**AGENDA
PLANNING & ZONING BOARD
SEPTEMBER 20, 2018
6:00PM**

WESTMINSTER PINE RIDGE ROADWAY & UTILITY DEVELOPMENT CONSTRUCTION PLANS CITY OF FRUITLAND PARK, FLORIDA

APPENDIX B

GRAVITY SEWER TO LIFT STATION & FORCE MAIN PLAN-PROFILE			
DESIGNED BY	DRAWN BY	CHECKED BY	APPROVED BY
GRC	JV	GRC	GRC

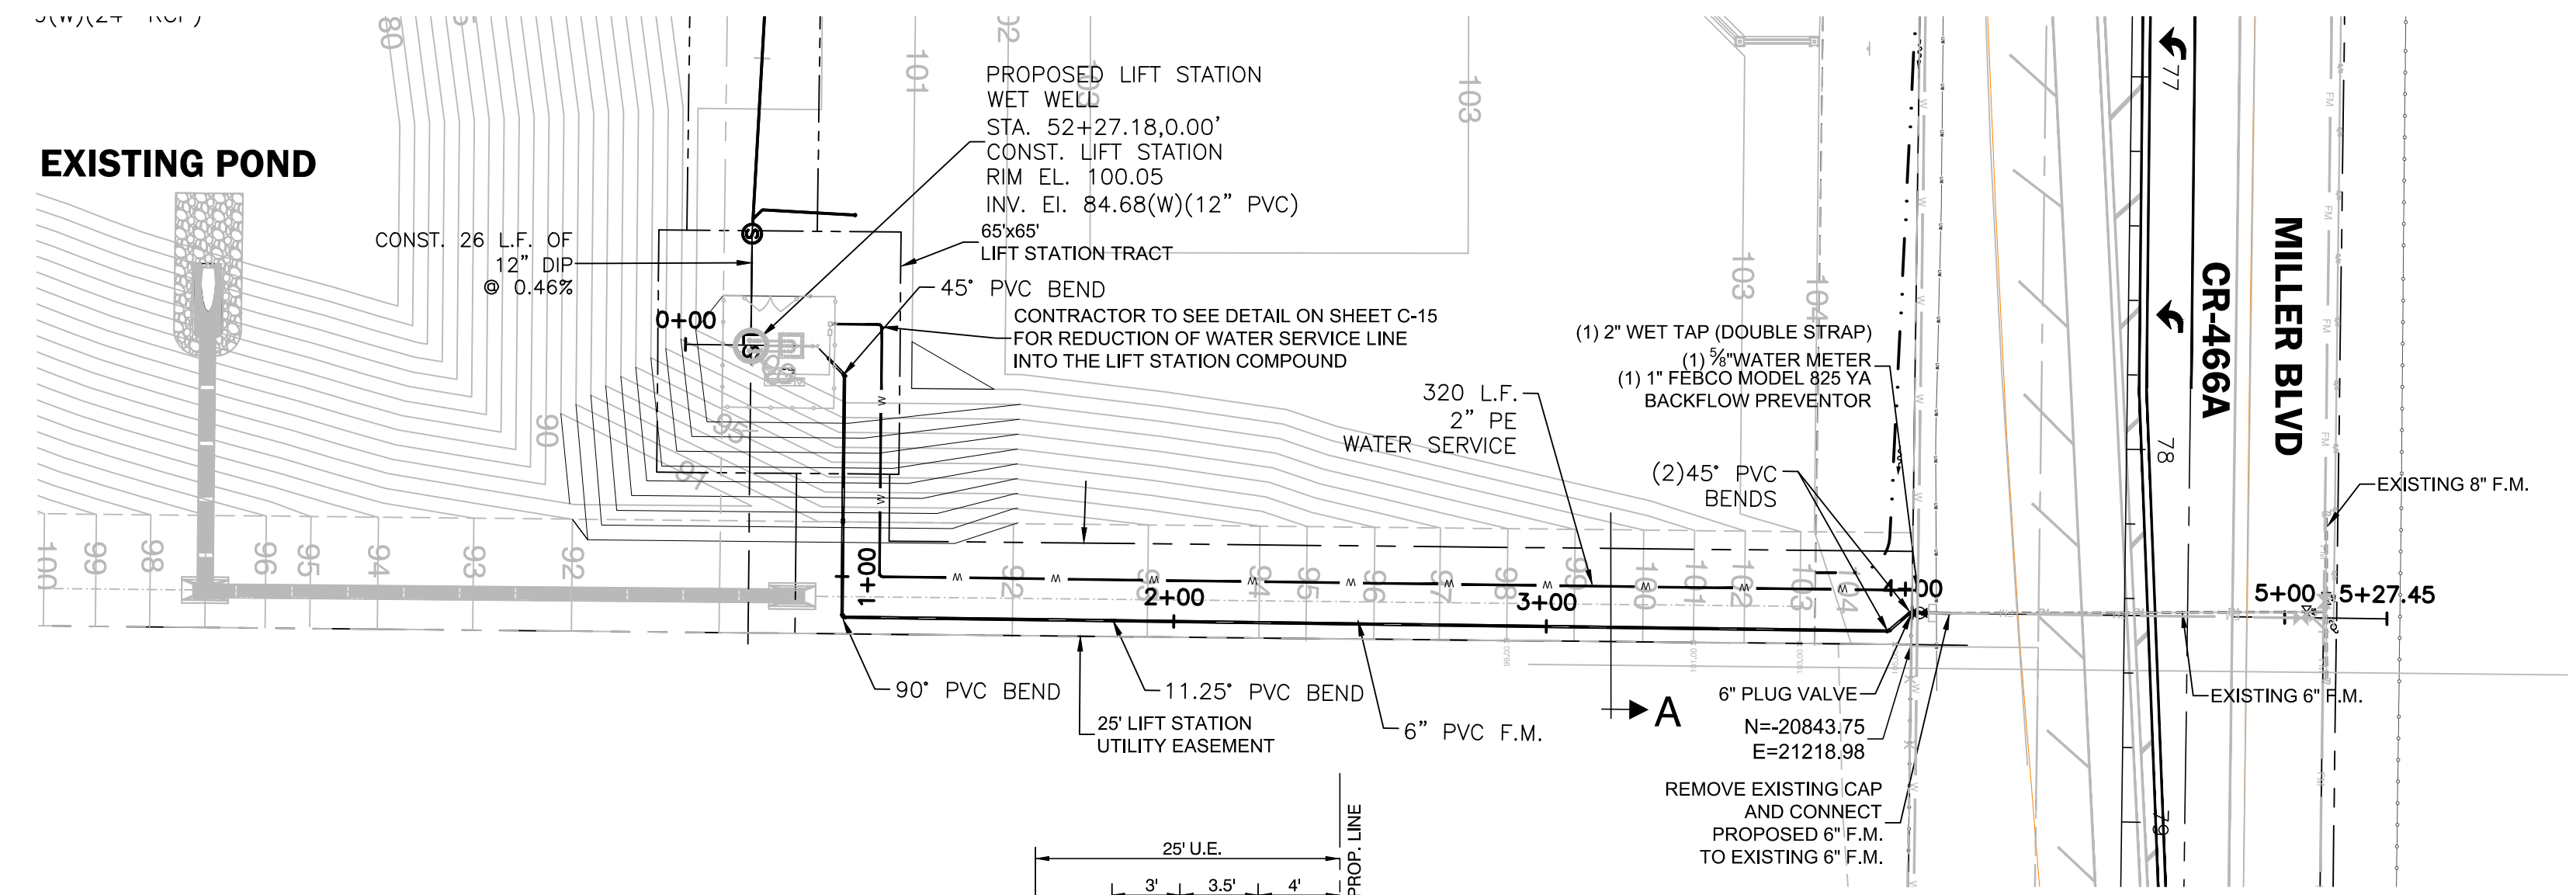
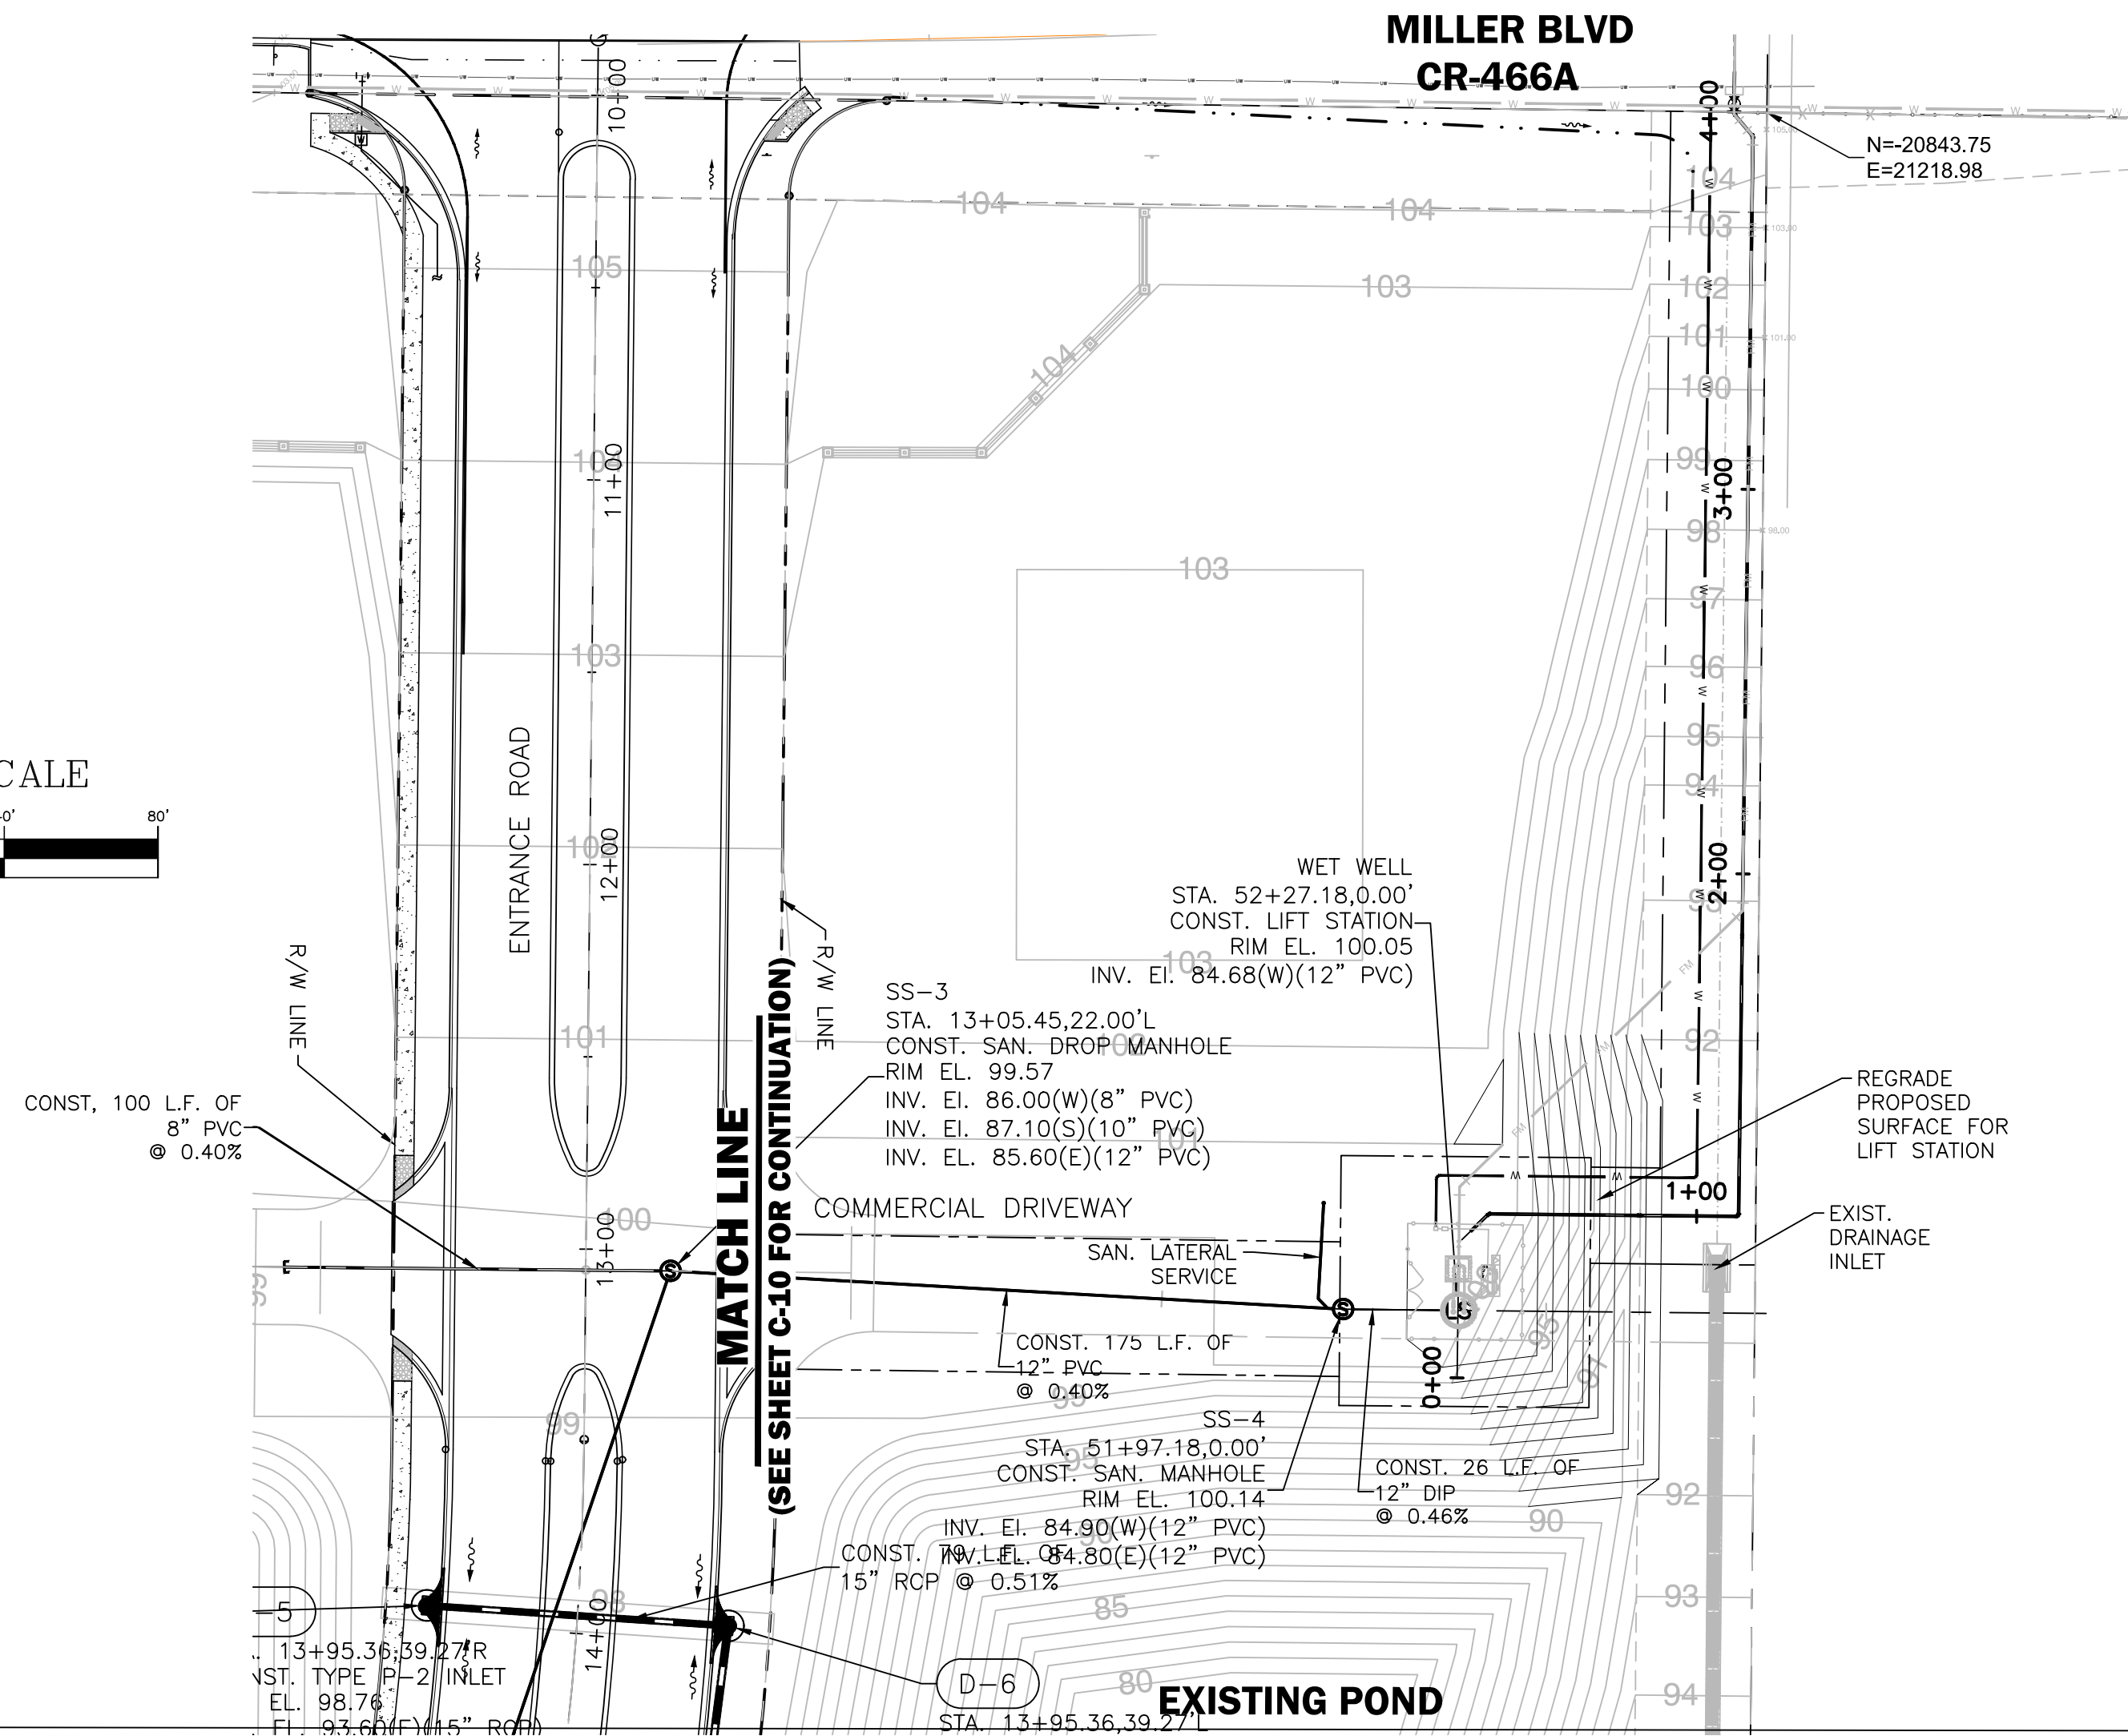
11. Sheet C-11 – Install a plug valve on the proposed force main at the right-of-way line.

12. Sheet C-10 and C-11 – Add a note that proposed utilities and lift station are to be privately owned.

Response: A plug valve has been added on the proposed force main on sheet C-11 as directed.

Response: A note has been added on sheets C-10 and C-11 as directed.
